ISSUE: Certificate of Appropriateness for alterations

APPLICANT: Old Town 1, LLC

LOCATION: Old and Historic Alexandria District
814 King Street

ZONE: KR / King Street Urban Retail

Figure 1: Existing Conditions 814 King Street

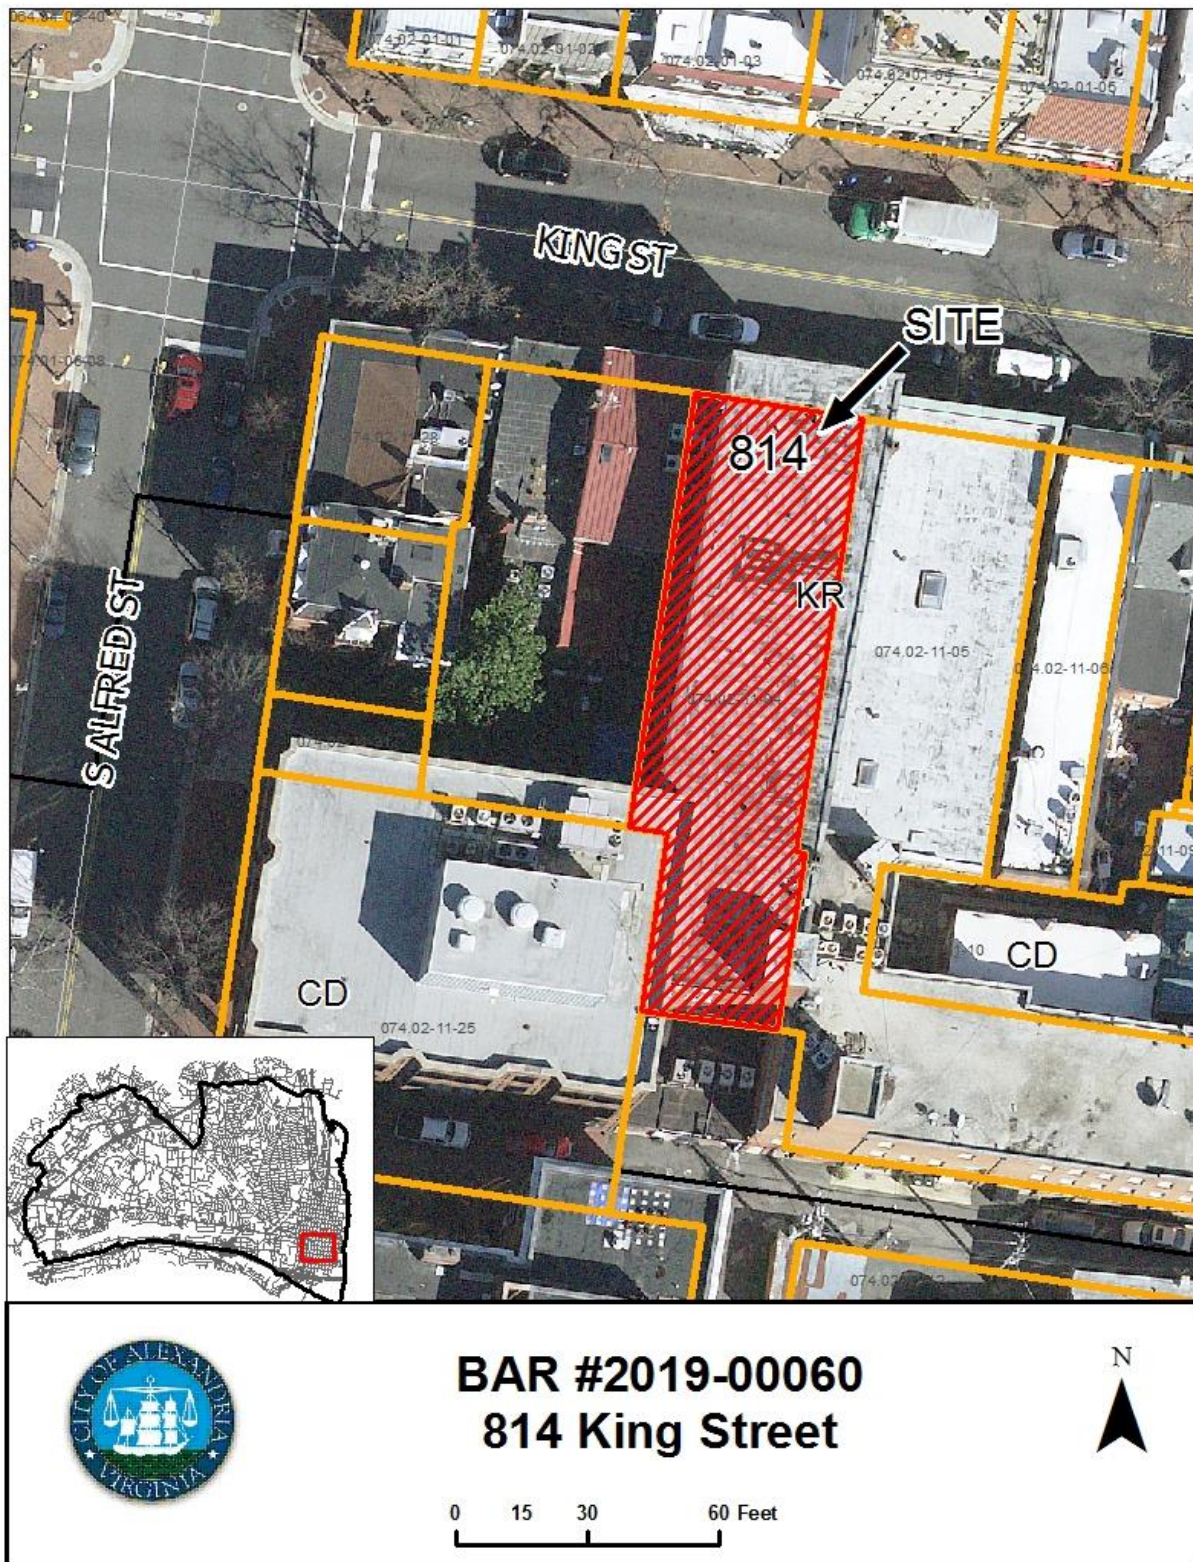
Staff is supportive of the new storefront and entrance alterations to the building, noting the need for appropriate lighting temperature/color and intensity levels. Staff supports the installation of the new C channel beam because it is architecturally consistent with the early 20th century industrial character of this building. The masonry surrounding the storefront on the first floor was previously altered and is not original to the building. However, with appropriate mounting of the header beam (see supplemental drawing detail ASK-1), the existing masonry building will not be damaged or destroyed and in the future this feature could be easily removed with little visual impact. The framing of the existing storefront bay windows, while sculptural, block the view of

retail displays and the applicant proposes a simpler, more open design. The *Design Guidelines* state “Reflective and tinted glass is not appropriate in the historic district”. As noted in the applicant’s materials, only clear glass will be utilized within the new aluminum storefront and entrance doors.

- 1, The brightness of the lighting at the entrance is subject to field inspection by staff to ensure lighting levels do not overwhelm the building or its neighbors
2. The final color/temperature of all lighting must be warm (not cool/blue) and no greater than 3000 Kelvin; and,
3. When the existing *Escape Room Live* sign and bracket is relocated due to the installation of the C channel it should be mounted through the mortar joints and not the masonry units.

Oberon LED Outdoor Wall Sconce

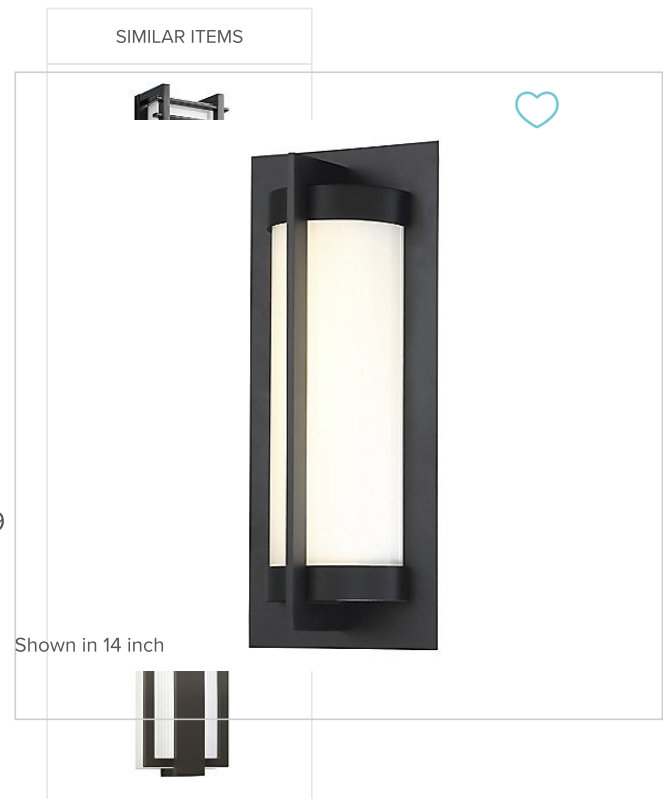
With respect to lighting and the relatively new LED technology being used, the BAR’s general direction to staff regarding architectural, or building, lighting is that the quantity of fixtures, the color of the light, the cumulative number of fixtures and overall brightness should not overwhelm the building or its neighbors on the block and that the brightness of the lighting should not be used as a *sign* for the business. Fortunately, the proposed facade light sconces will utilize modern LED dimming technology. In consultation with staff on-site at night, lighting levels should be field adjusted as necessary.

The issue of the color, or temperature, of LED lights has also been discussed by the BAR in the past few years as these energy efficient bulbs have become more popular and the consensus has been that the color of the LED lighting should be warmer (yellow) rather than cooler (blue) and have a temperature measuring no greater than 4000 Kelvin, with 3000 Kelvin strongly preferred. Based on staff’s recent experience with the replacement Gadsby street lights, the warmer light colors are now more widely available than they were several years ago, and all the new City street lights are expected to be 3000K, as requested by the BAR. The proposed specific sconce manufacturer details indicate the new lighting fixtures are dimmable from 10%-100% and the color temperature is 3000K. Staff supports the installation of these new energy efficient lighting fixtures.
